RE: **Lot 11 Block 6, Volcano Cliffs, Unit 18, SAD 228
6527 Papagayo NW
Grading and Drainage Plan
Engineers Stamp Date 3/2/20 (D10D003L11)**

Based upon the information provided in your submittal received 3/3/20, this plan is approved for Grading Permit.

DRAINAGE AND TRANSPORTATION INFORMATION SHEET (REV 6/2018)

ENGINEER'S SEAL DAVID SOULE NEW MEXICO REGISTERED PROFESSIONAL ENGINEER 14522 3/2/20	LOT17 BLK7 U18 VOLCANO CLIFFS SUB. 6527 PAPAGAYO ROAD N.W.	DRAWN BY DEM
	GRADING AND DRAINAGE PLAN	DATE 2-28-20
 1608 CENTRAL AVENUE SE SUITE 201 ALBUQUERQUE, NM 87106 (505) 972-0899		SHEET # C1
		JOB #

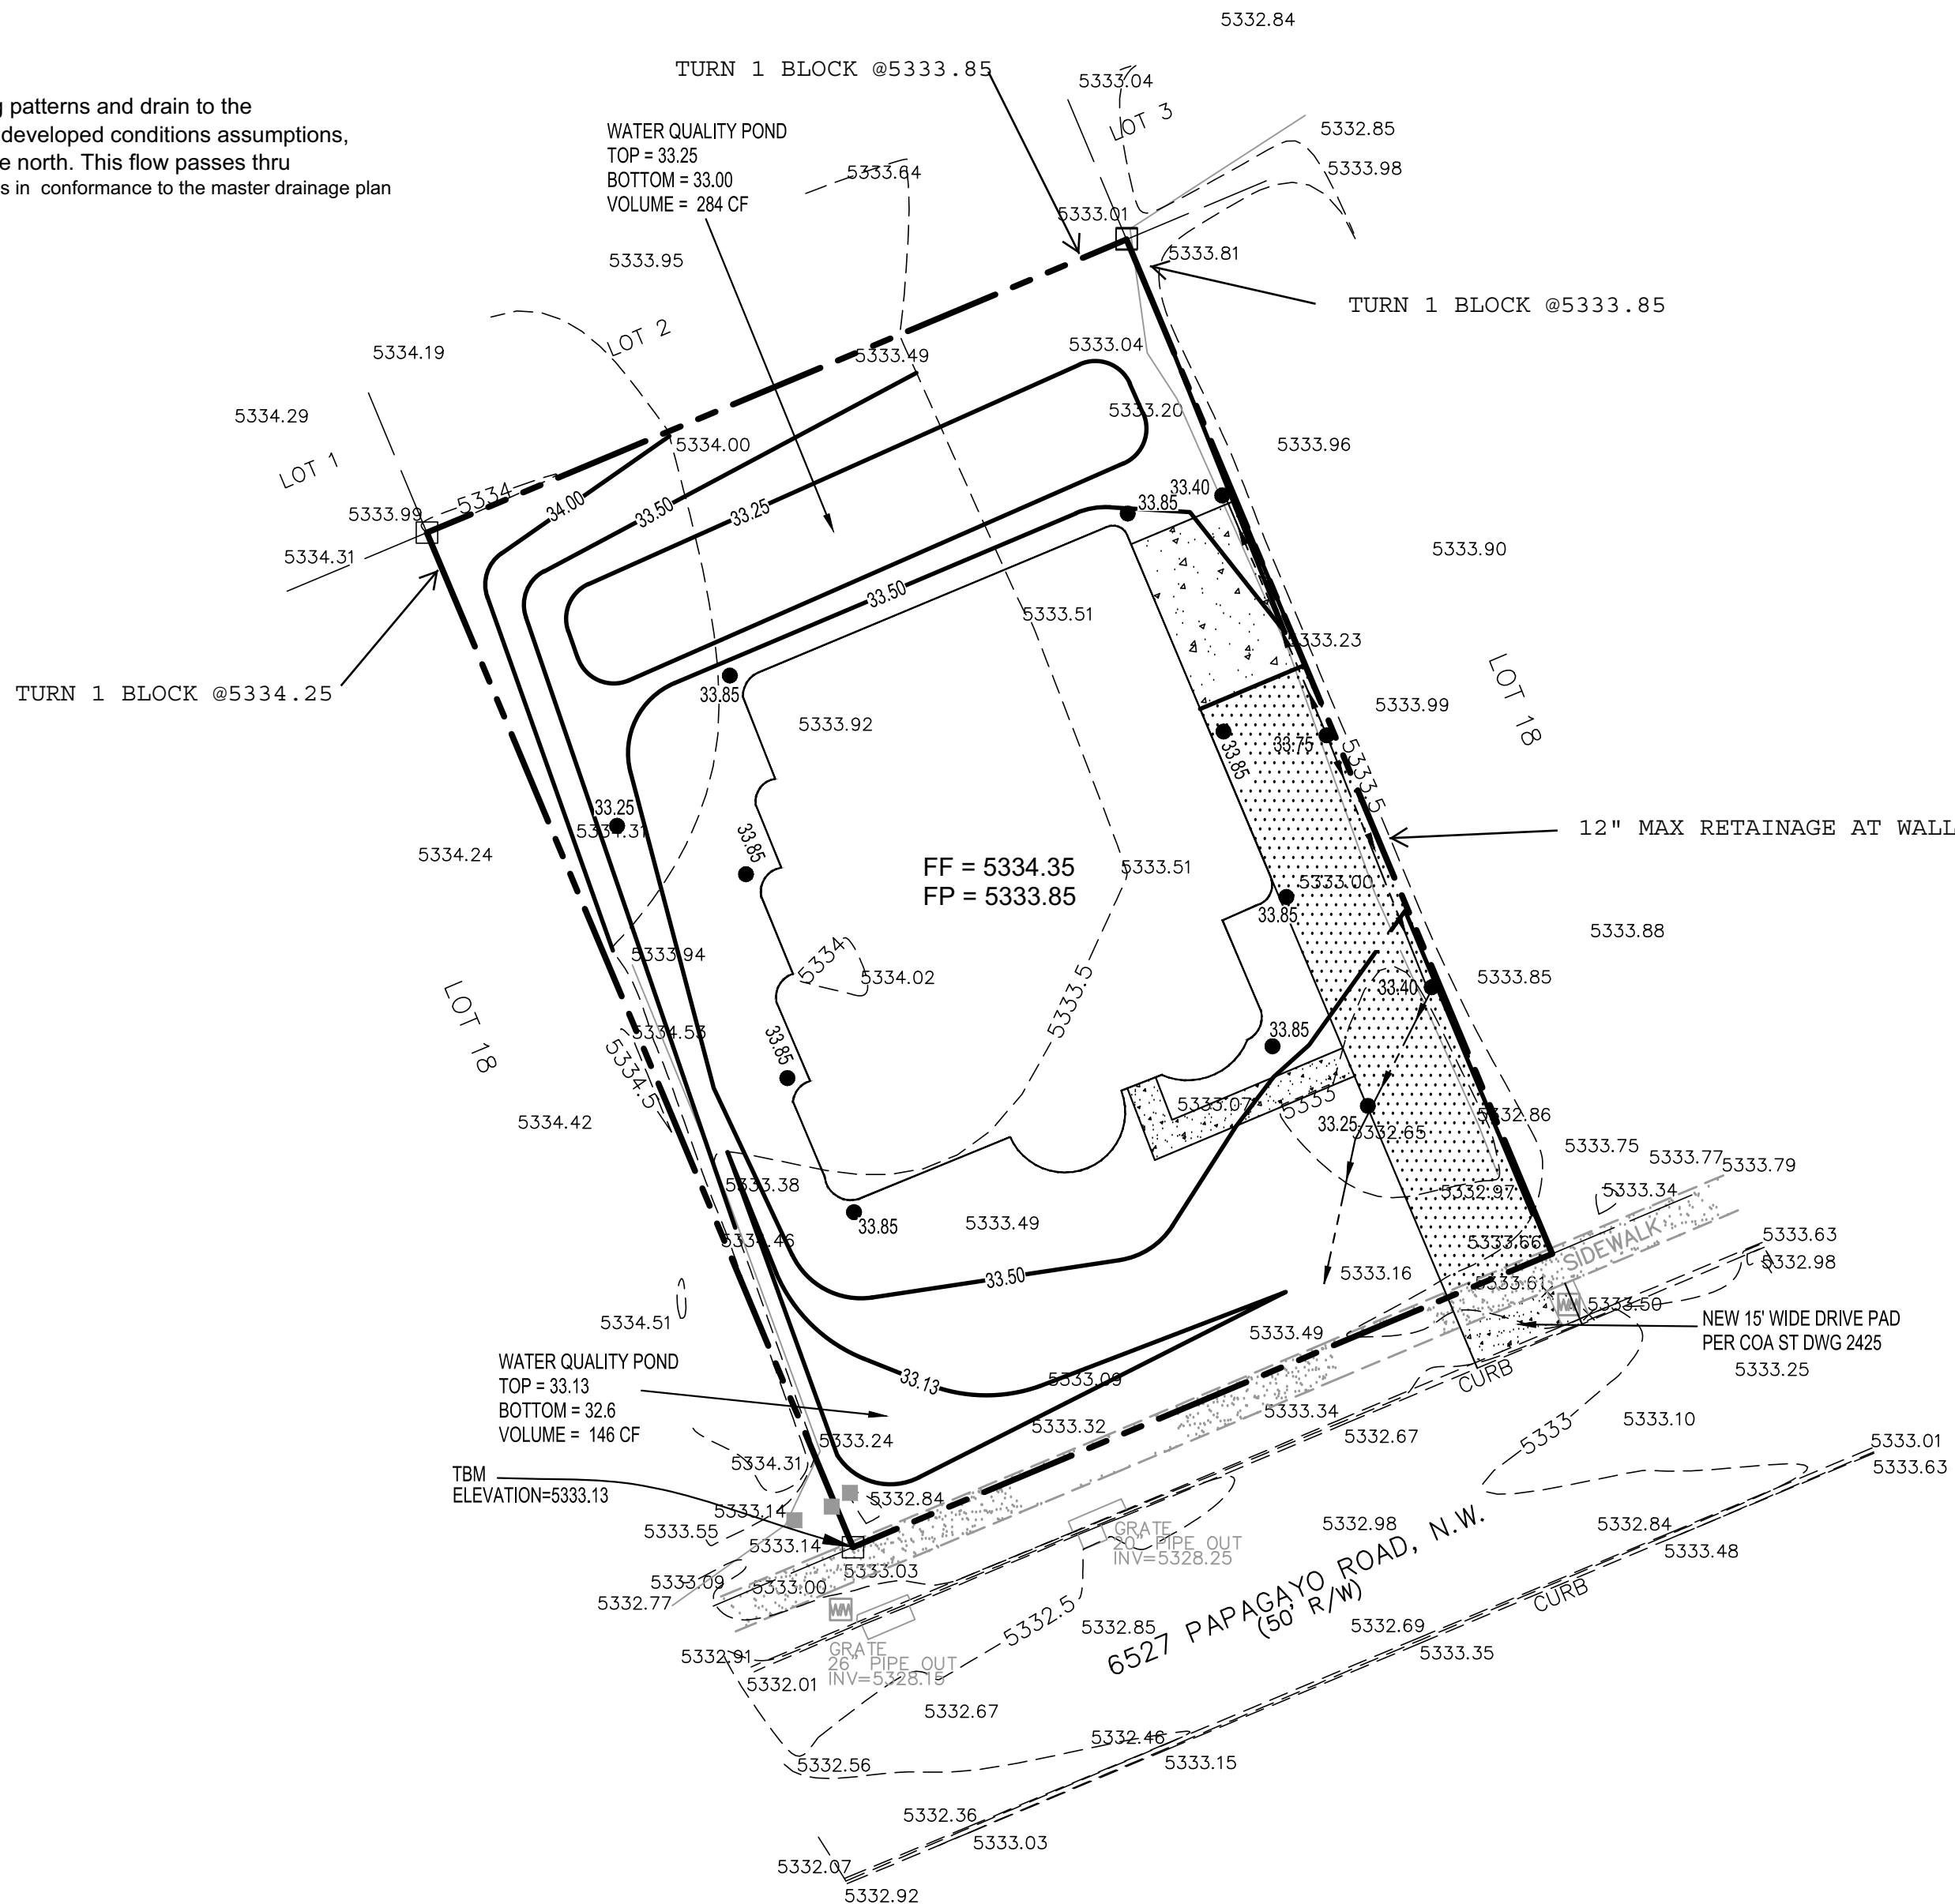
Prior to Building permit approval a Pad Certification will be required, provided by the Engineer or a registered Land Surveyor.

Advise the owner contractor not to use dirt as a ramp to climb the curb, use lumber or crusher fines for this purpose.

Reiterate to the Owner/Contractor that a separate permit for a garden/retaining wall must be obtained with the approved G&D plan and Pad Certification. Also, if a swimming pool is to be placed the grading and drainage plan will change and will need to be resubmitted.

Prior to Certificate of Occupancy release, Engineer Certification per the DPM checklist is required.
